Planning Board

Agenda

March 10, 2026, 2:00 PM

2. 26-357 400 E. GREGORY STREET – GATEWAY REDEVELOPMENT DISTRICT – CONCEPTUAL SITE PLAN AND AESTHETIC REVIEW

CONCEPTUAL SITE PLAN

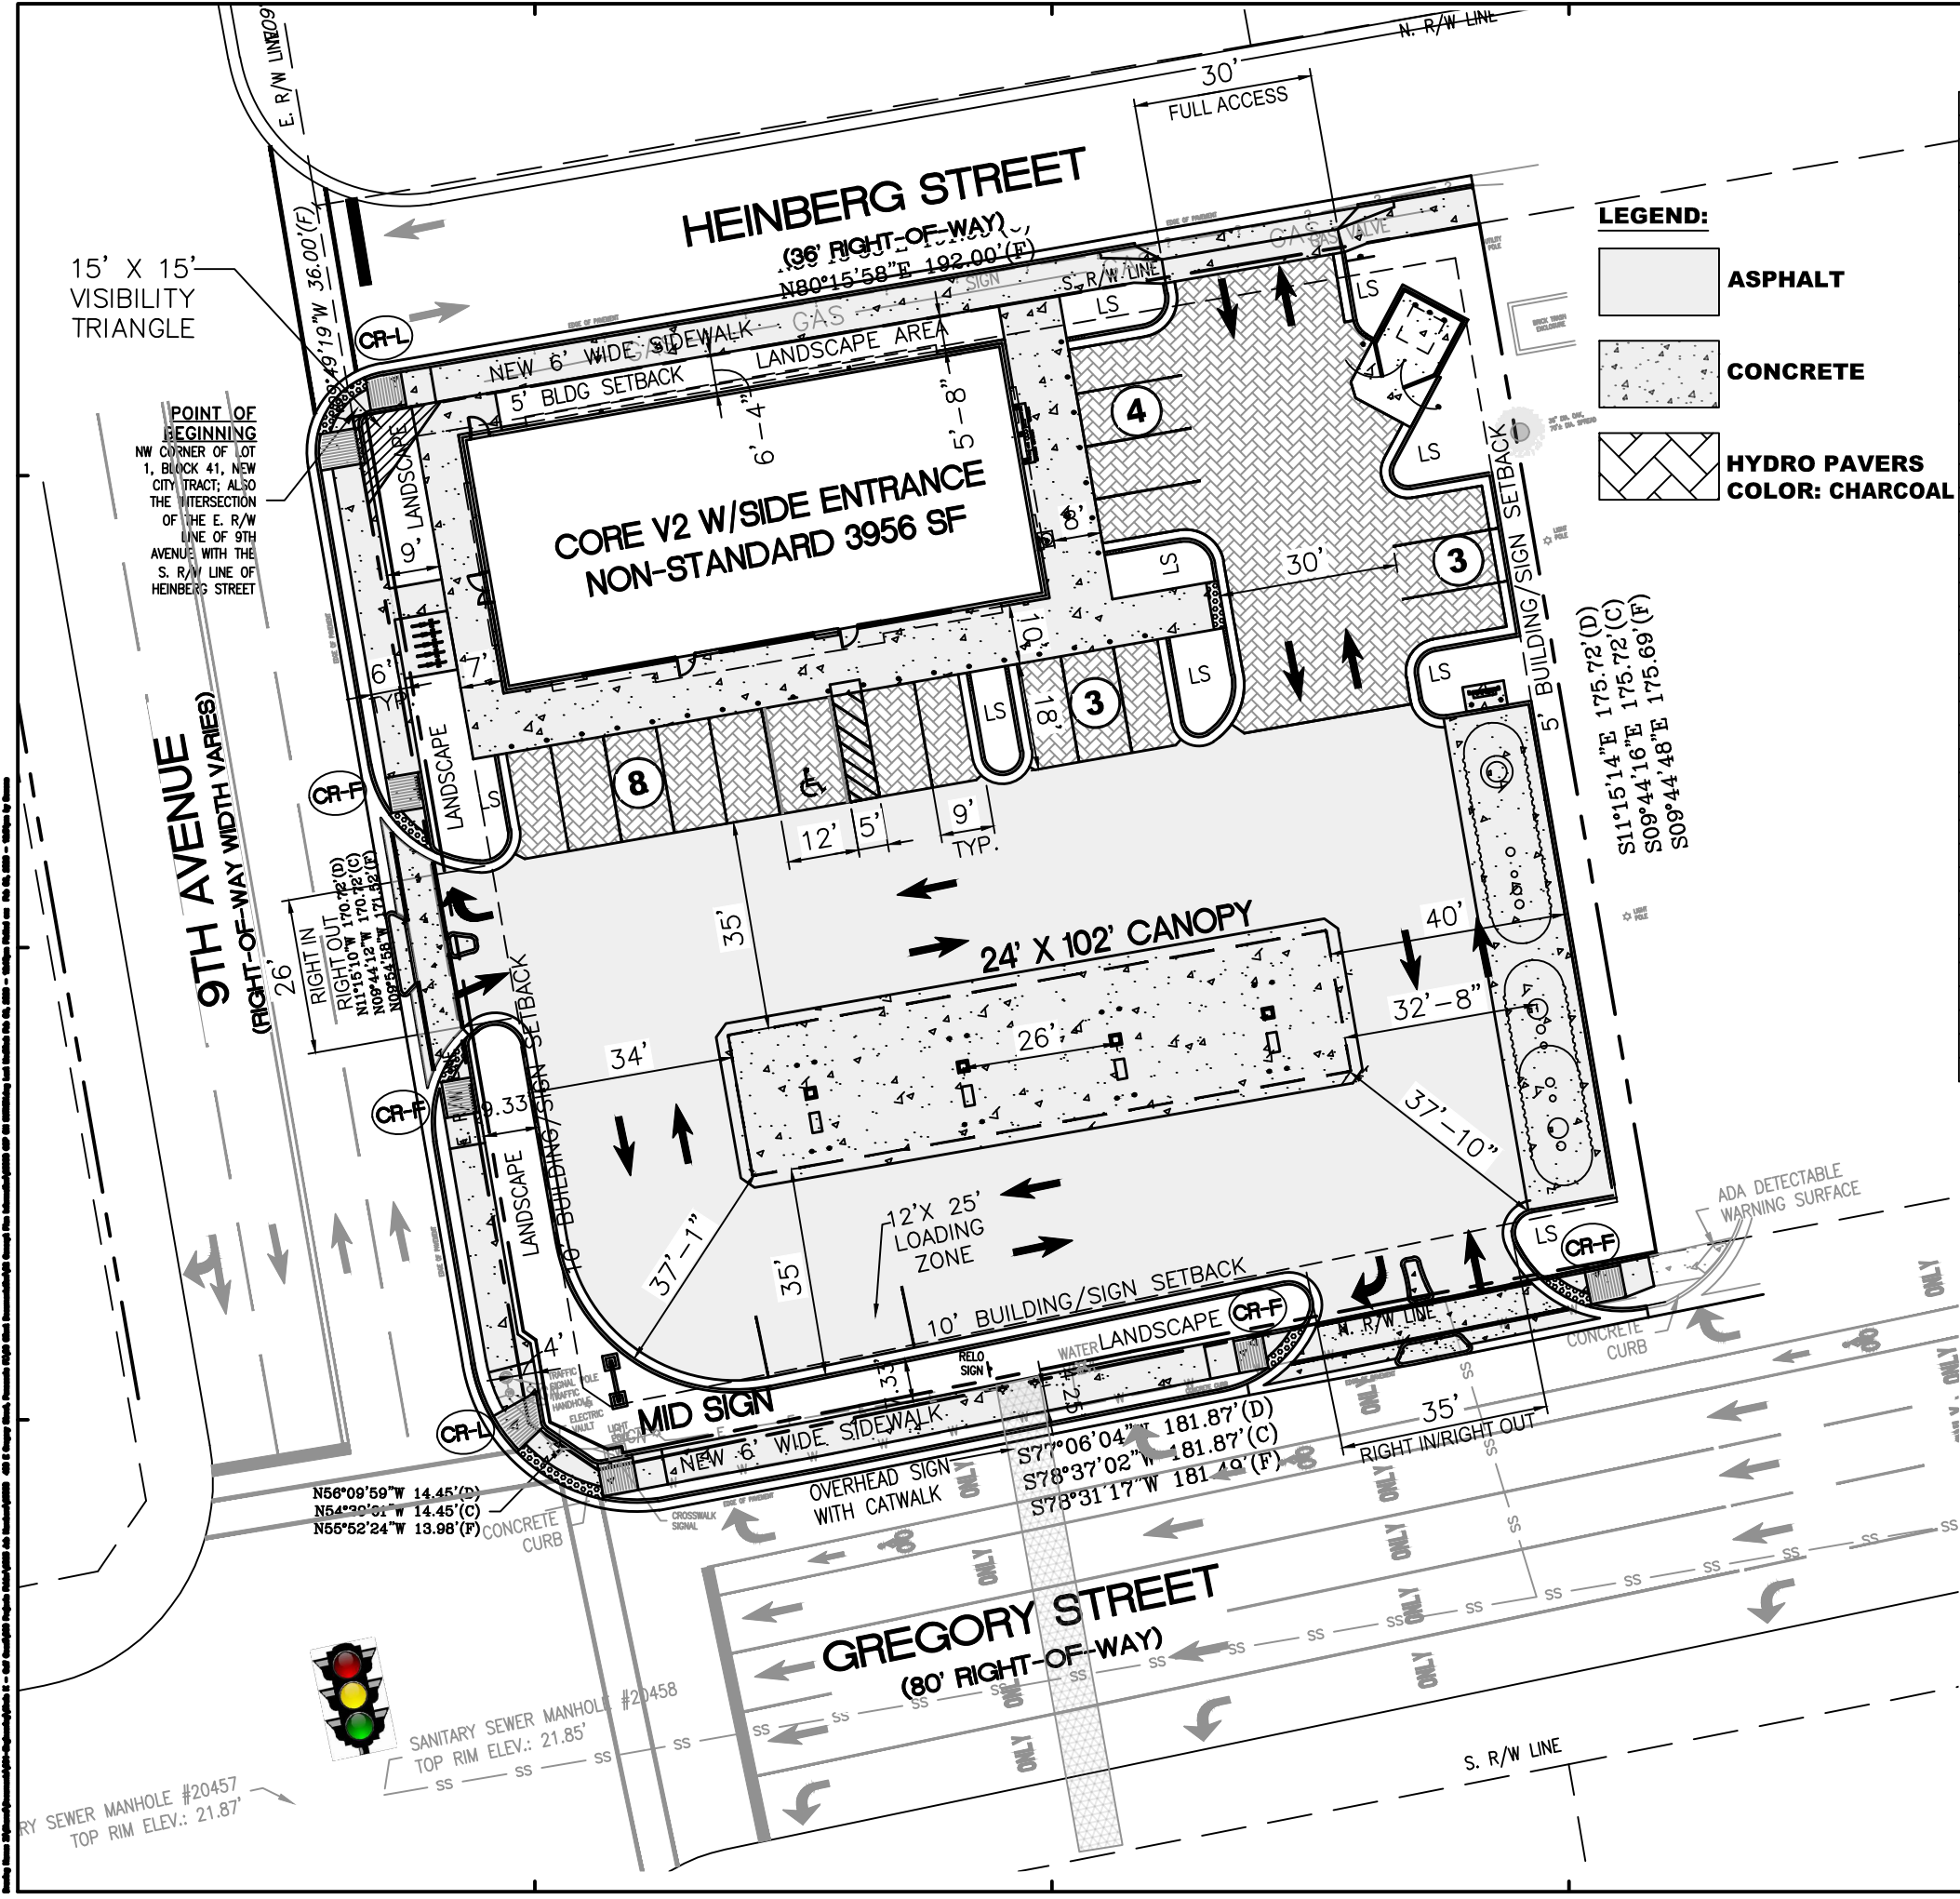
Department:	Comments:
Planning	No further comments on conceptual review.
FIRE	No comments.
PW/E	No comments.
Surveyor	No comments.
Inspection Svcs	No comments.
Pensacola Energy	No comments.
ECUA	No comment on the aesthetic review. ECUA has been in contact with the developer regarding the site design water/sewer permitting.
FPL	No comments.
ATT	AT&T has no issues with this project.
FDOT	No comments.
CRA	No comments.
Parking	No comments.
Airport	No comments.
Arborist	While there are no Heritage or protected trees located on the project site, there is an existing heritage oak tree immediately east of the property boundary, near the proposed dumpster bay. As the dripline and root zone of this tree extend onto the project property, a Tree Protection Barrier Zone will be required in accordance with Section 12-6-6.2(a)(2).
Floodplain	I have no comments on this one.
Traffic Operations	9 th Ave. and Gregory are FDOT jurisdiction and Heinberg is the city jurisdiction. All public infrastructure deficiencies that may be noted through completion of the project need to be resolved by the owner or owner's contractor.

NEW WORK SITE PLAN

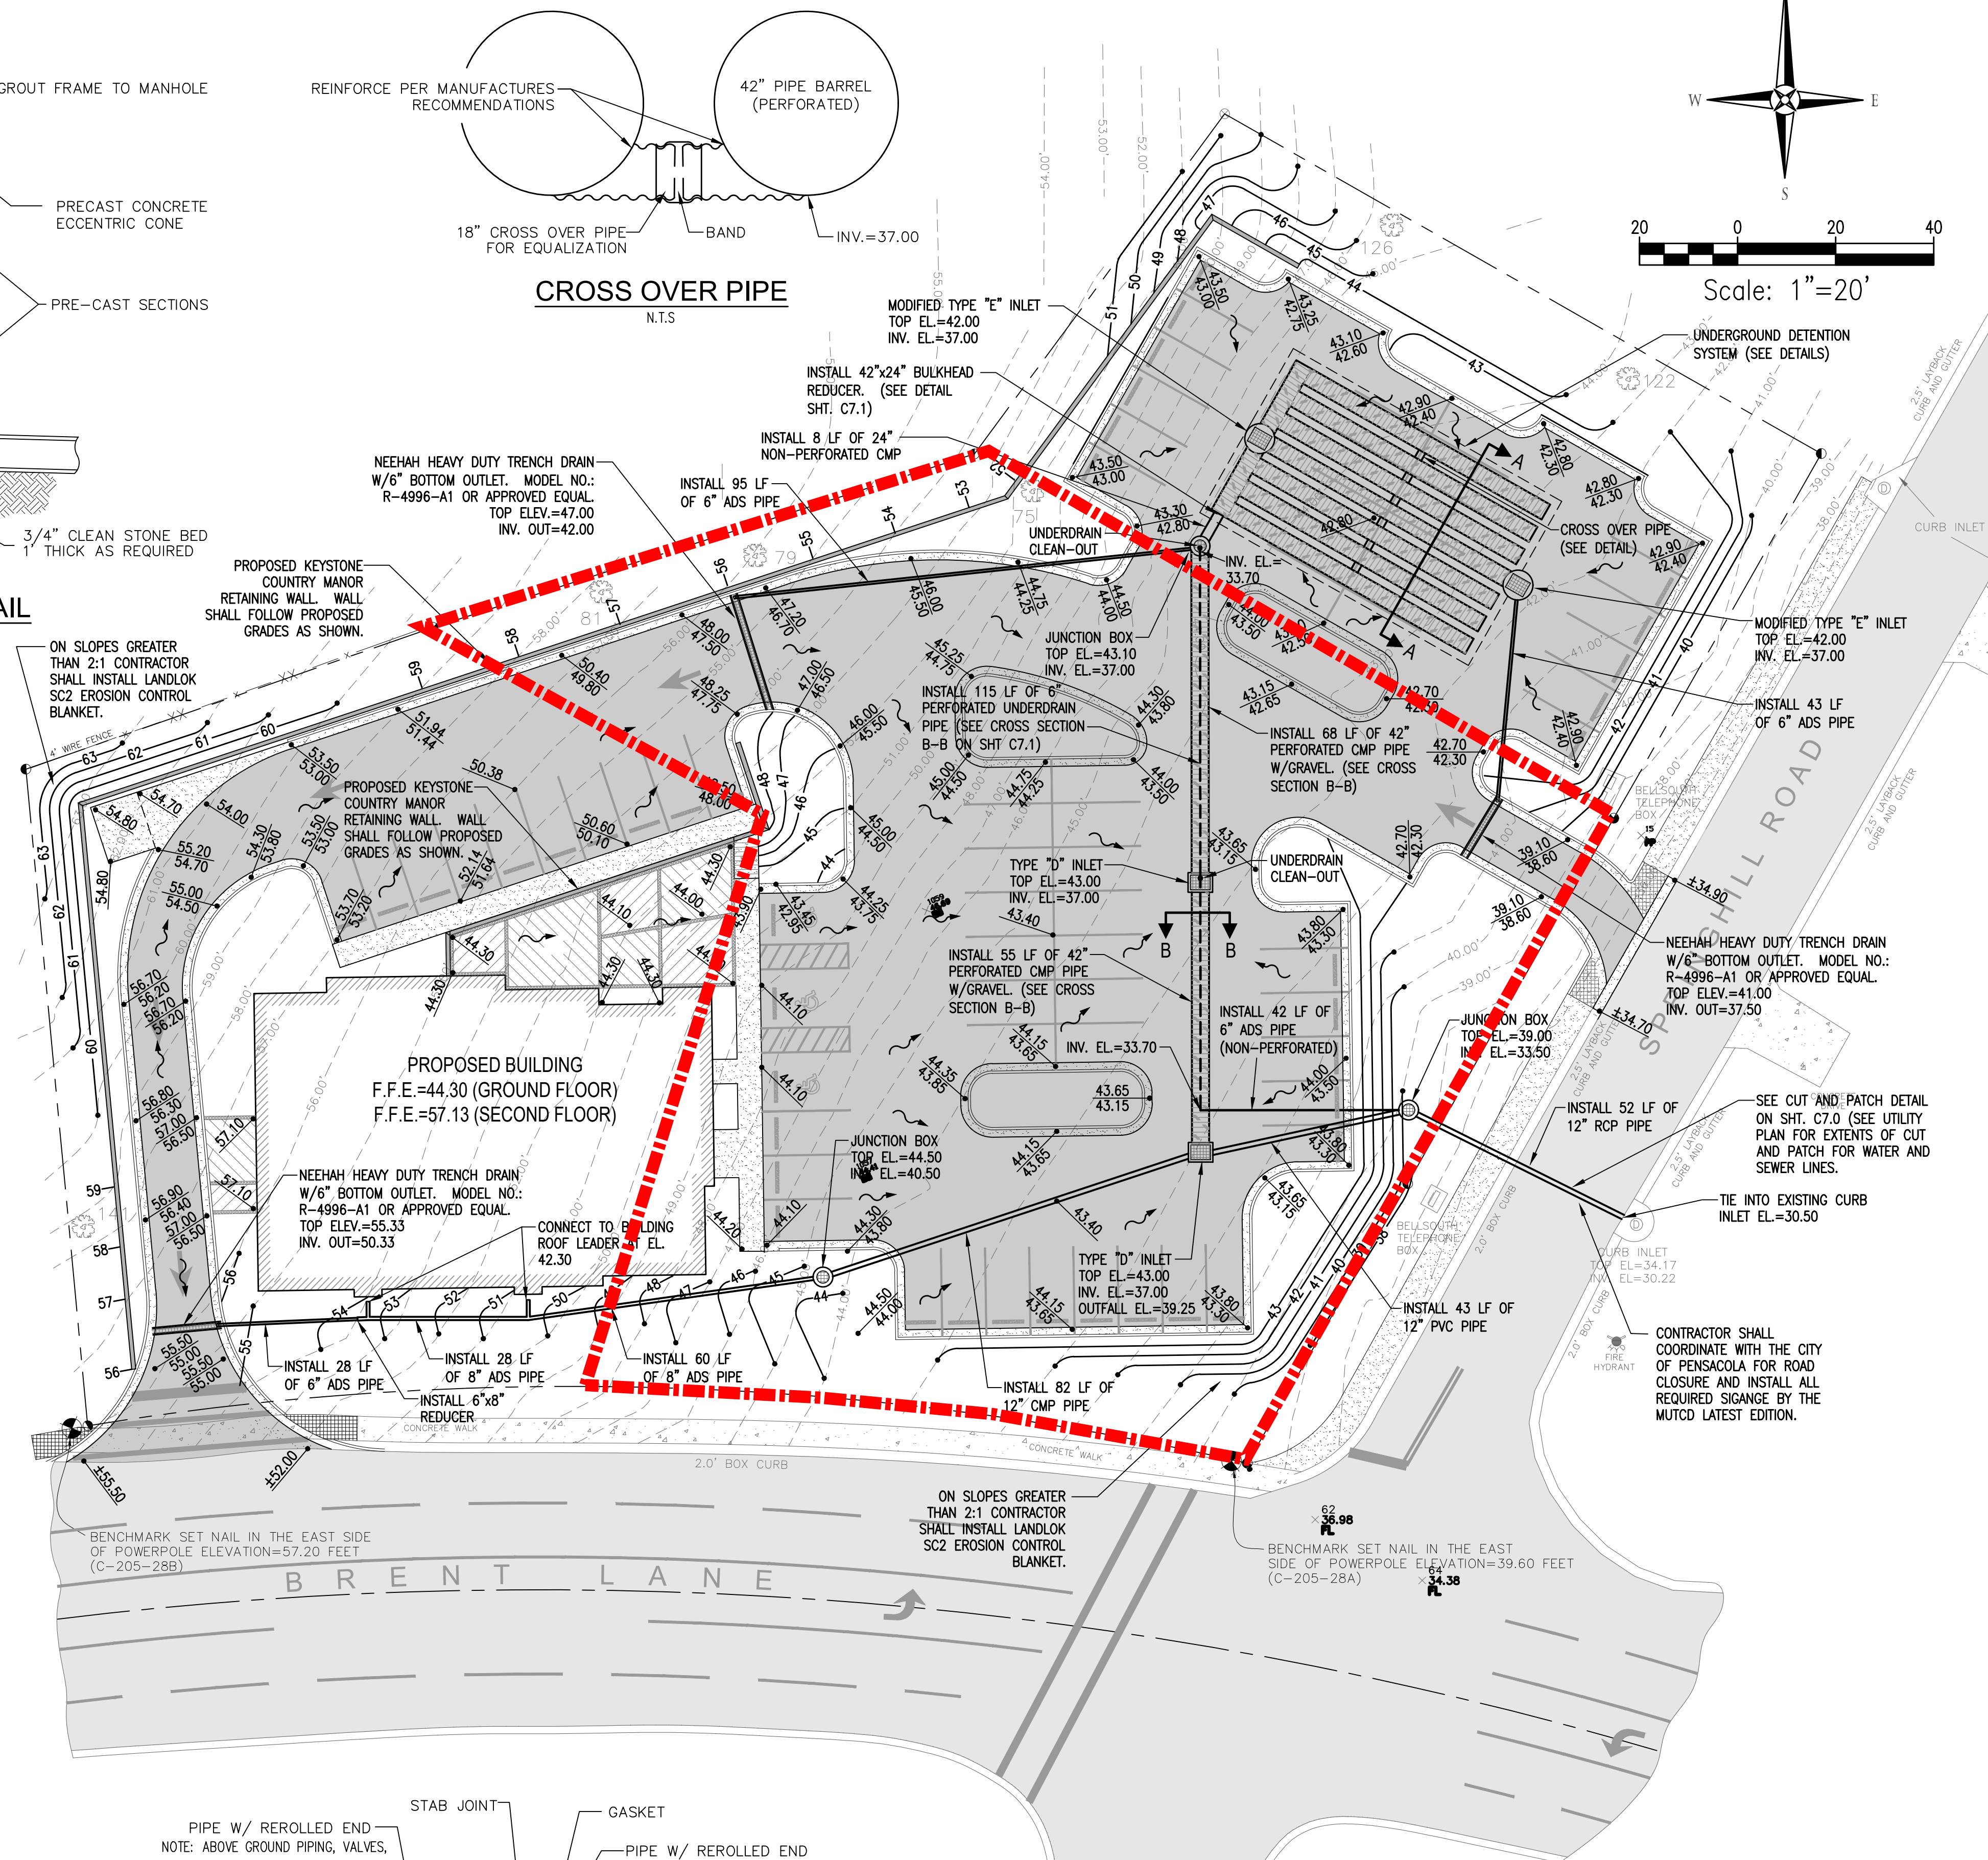
Department:	Comments:
Planning	No additional comments.
FIRE	No comments.
PW/E	Conceptually, this is amenable. Obviously, we'll require the Engineer of Record to supply sign and sealed construction plans as well as stormwater calculations to verify compliance with the LDC. But, both the submitted conceptual plan as well as our discussions with the developer have indicated that full compliance with the LDC will ultimately be achieved.
Surveyor	No comments.
Inspection Svcs	No comments.
Pensacola Energy	No comments.
ECUA	No concerns with the proposed parking area.
FPL	No comments.
ATT	AT&T has equipment out front. As long as we don't need to move it AT&T does not have a problem with this project. If the equipment needs to be moved, please call 888-901-2779.
FDOT	As far as FDOT is concerned this is a non-issue. Very happy to see that they did remove the existing connection and relocate northerly/away from the intersection.

Arborist	Please note the following comments to be addressed prior to and during construction: 1.Irrigation An irrigation system shall be provided for all proposed landscape areas. The type and general location of the irrigation system shall be identified, and the system shall provide 100% coverage to all required and proposed landscape areas to ensure proper establishment and long-term survivability of plant material. 2.Tree Protection Measures Tree Protection Zones (TPZs) and appropriate tree protection fencing shall be installed for Trees 1, 2, and 3 prior to the start of construction activities. Tree protection measures shall remain in place for the duration of construction to prevent impacts to root systems and critical tree areas. 3.Buffer Area Tree Plantings Any trees planted within designated buffer areas shall be a minimum of 3-inch DBH or greater at the time of planting. 4.Tree Spacing at Brent Lane & Springhill Intersection Sunshine Ligustrum will not be considered a tree for the purposes of meeting required tree spacing. As such, Sunshine Ligustrum shall not count toward the required 35-foot tree spacing at the corner of Brent Lane and Springhill. All trees planted in this area shall be spaced and installed in a manner that meets the required 35-foot spacing between qualifying trees. 5.Landscape Summary Metrics Prior to construction, please provide the following summary information for the project: - oTotal DBH of trees proposed for removal - oTotal DBH of trees pre-existing on site - oTotal percentage of landscaped area within the site
